Staff Report

HEARING DATE: May 27, 2015

APPLICATIONS: **South Cooper Mountain High School - land use case files
CU2015-0003, DR2015-0029, LD2015-0004 and ADJ2015-0004**

REQUEST: Beaverton School District proposes to construct a new high school. At full enrollment, the proposed 320,000 square foot school building is designed to accommodate approximately 2,200 students and 200 staff. One vehicular access to the school is proposed from SW 175th Avenue and is intended for parents and students. Another vehicle access to the school is proposed from SW Scholls Ferry Road and is intended for buses and staff. Both vehicular access points are proposed to be signalized. The proposal includes several outdoor sports facilities and two parking lots that will provide a total of 550 parking spaces. The proposal also includes modification and enhancement of existing wetlands.

SITE PLAN FOR NEW HIGH SCHOOL

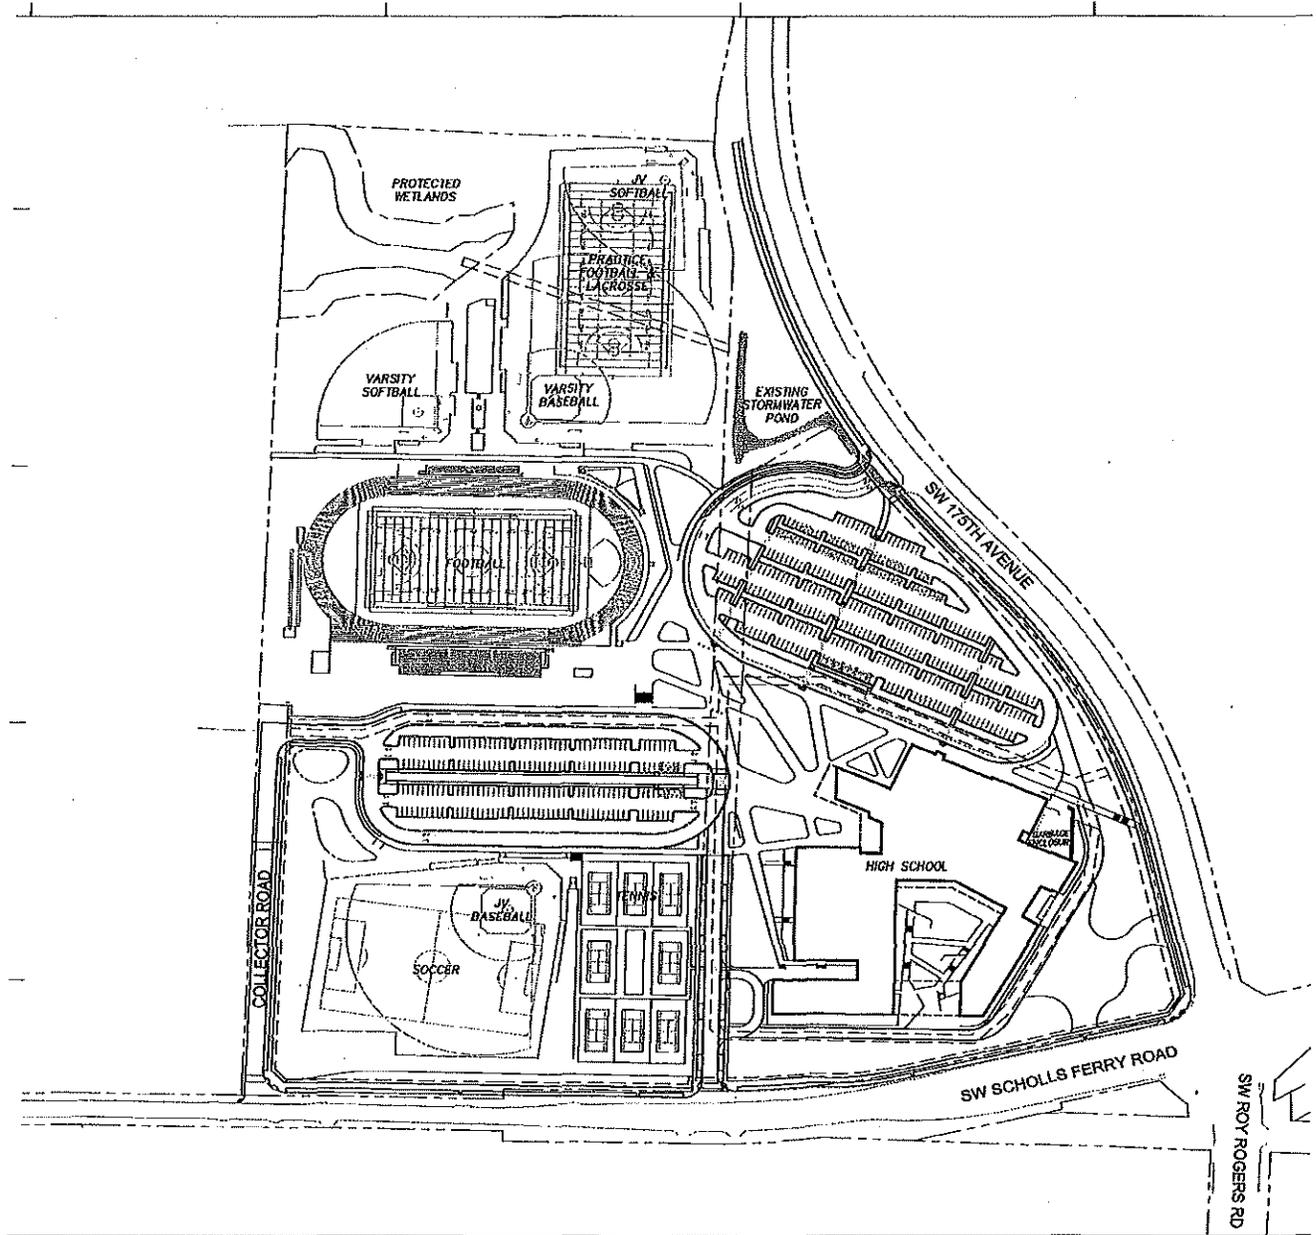
The applicant is encouraged to modify Sheet L100 (the Pedestrian Circulation Plan) to show which walkways and sidewalks meet ADA requirements and to indicate the preferred paths bicycle riders are to use for accessing the site and the bicycle parking areas. The pedestrian and bicycle rider circulation plan should also indicate the widths and materials of the paved walkways and pathways.

Staff also refers to Sheet L100 of the applicant's plan set that illustrate the circulation plan for pedestrians. Sheet L100 clearly describes the internal walkway system to be provided through the campus, in addition to a pedestrian-only connection provided to SW 175th Avenue. Sheet L100 also identifies future pedestrian access to the school campus when properties to the west are developed as part of the SCM Community Plan.

Staff find the proposed on-site pedestrian pathway system to be safe and efficient because pathways are separated from vehicular traffic. Due to the grade of the property, some of these pathways will not be ADA accessible. Also, where Section 60.55.25.10 of the Code requires a walkway into a development to be provided for every 300 feet of street frontage, the school proposal does not show compliance with this standard. Staff recommends an additional pedestrian access provided to SW Scholls Ferry Road if such pedestrian access is determined to be feasible.

As a condition of approval, the plans subject to Site Development and Building Permit are to identify pavement differentiation and ramps as necessary for ADA compliance. To the Student/Visitor parking lot (best illustrated on Sheet L211) pedestrian crossings are shown between vehicle parking/access aisles. Improvements to this part of the campus indicate the pathway demarked by striping (paint). The proposed conditions also require pathway and connections to be constructed with scored concrete or modular paving patterns. Staff also recommends the addition of signs that demark the location of pedestrian crossings at this location.

Figure 10: Community Plan Street Framework

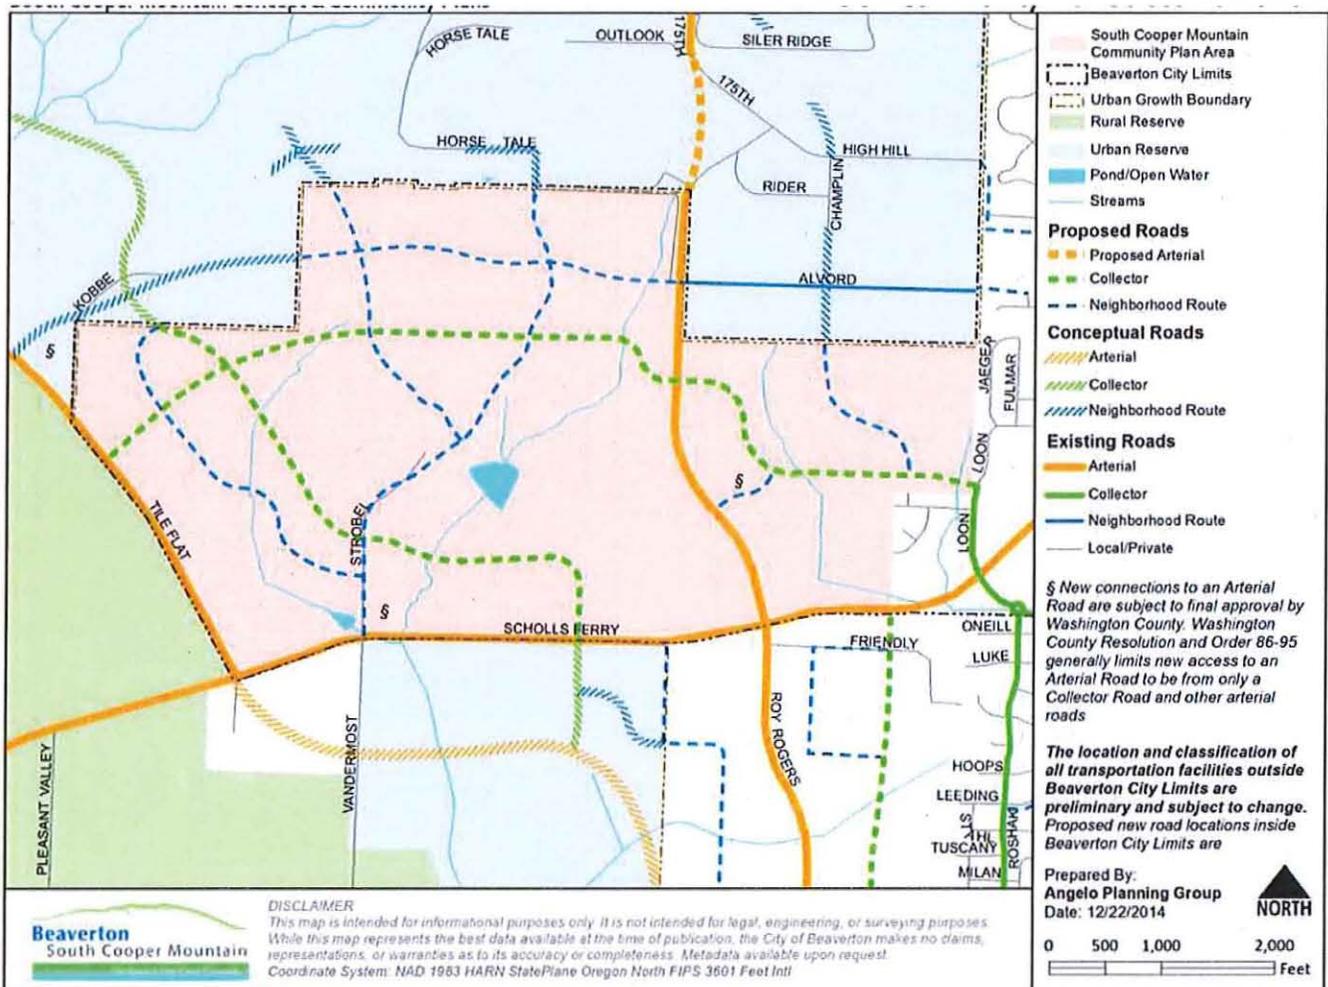
Street Classifications - South Cooper Mountain Community Plan (SCM Plan) consistency: At the northwest corner of SW Scholls Ferry Road and SW 175th Avenue, the high school property is located within the SCM Plan. Figure 10 of the SCM Plan identifies the Street Framework plan identifying the classification of existing and proposed roads. That portion of SW Scholls Ferry Road, abutting the south boundary of the school property is classified as an Arterial and is planned for five lanes. Similarly, that portion of SW 175th Avenue abutting the school property (east boundary) is classified as an Arterial and is planned for five lanes. Abutting the western boundary of the school property is a proposed/future Collector class street (unnamed at this time).

Vacation of Old 175th Right-of-way: The existing unimproved right-of-way (old 175th) that runs north – south through the subject property has no significance to the SCM Street Framework Plan and is not shown to the map in Figure 10 thereof. Washington County has also commented in response to the District's proposal to vacate the existing right-of-way. The high school property is currently bisected by the right-of-way. In part, the purpose of the applicant's Preliminary Partition application (case file LD2015-0004) is to create one legal lot of record where the right-of-way that divides the property would not be shown. Washington County, by signing all land use applications associated with this proposal, consents to the city land use processes under review. However, a separated land use process through Washington County remains for vacating the right-of-way.
